HISTORIC DISTRICTS REVIEW BOARD FIELD TRIP

4. Case #H-18-124B, 636 Garcia Street. Downtown & Eastside Historic District. D. Maahs Construction, agent for David and Rebecca Glover, owners, proposes an 80 sq. ft. addition adjacent to a primary façade; an approximately 80 sq. ft. addition to the rear casita; changes to various doors, windows, walls, and gates; and reroof/restucco maintenance on a contributing residential property. Three exceptions are requested – an addition within 10' of a primary façade (14-5.2(D)(2)(d)); additions which exceed 50% of the historic footprint (14-5.2(D)(2)(d)); and replacement of historic material not in-kind (14-5.2(D)(5)(a)). (Carlos Gemora)

MINUTES OF THE
CITY OF SANTA FE
HISTORIC DISTRICTS REVIEW BOARD

February 12, 2019

Proposed Floor Plan

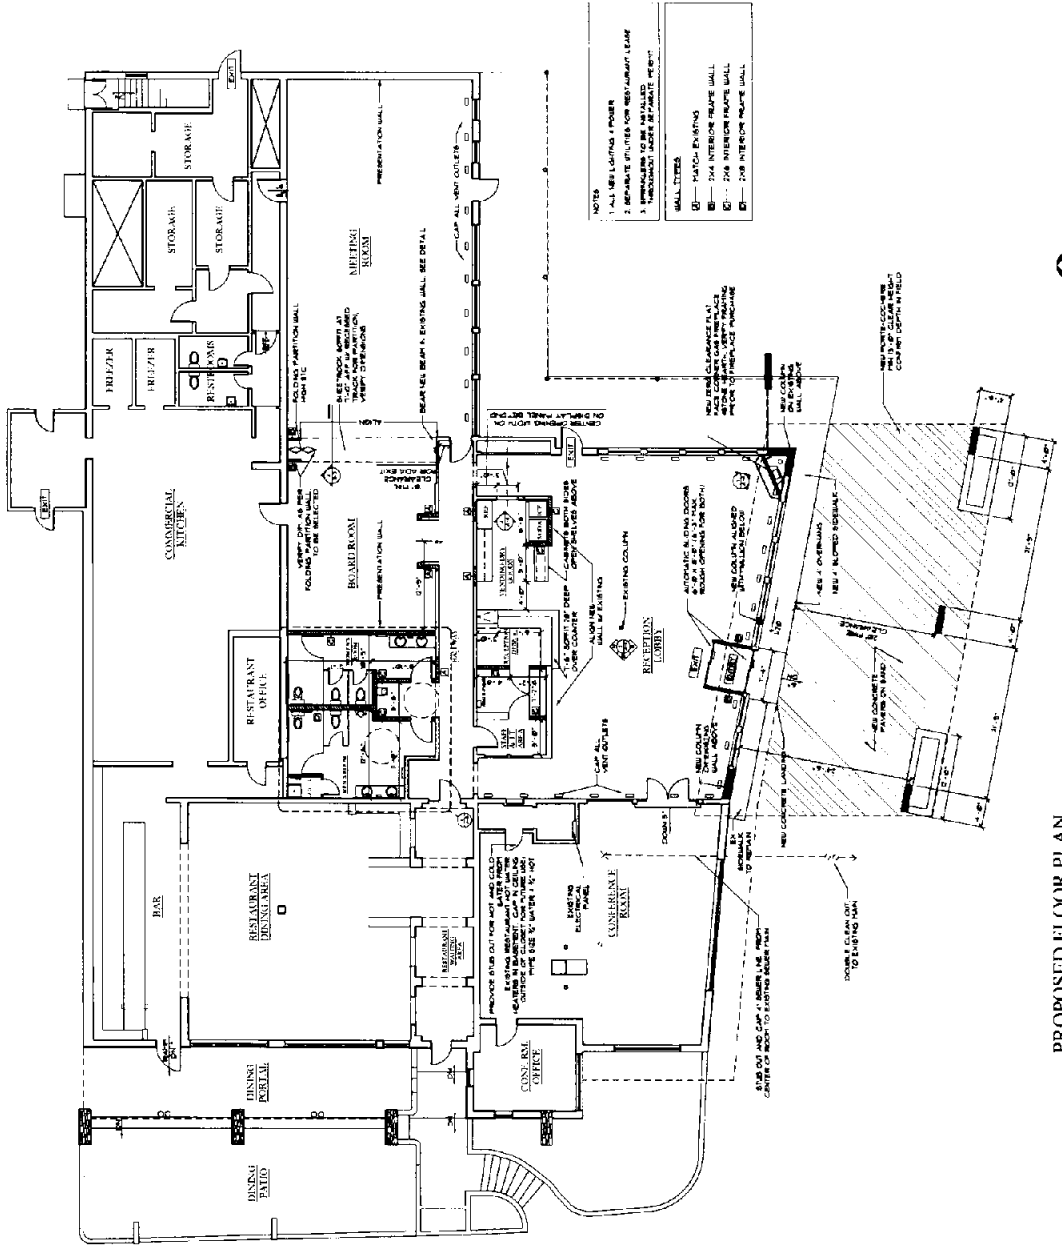
That is the phase for this season. It will have a small gas fireplace and handicapped access to the building. Sheet A-2 shows a new sloped sidewalk and 5' deep landing so at 1:20, it needs no rails to the lobby landing through the new doors. They are using existing vestibule and door locations there now
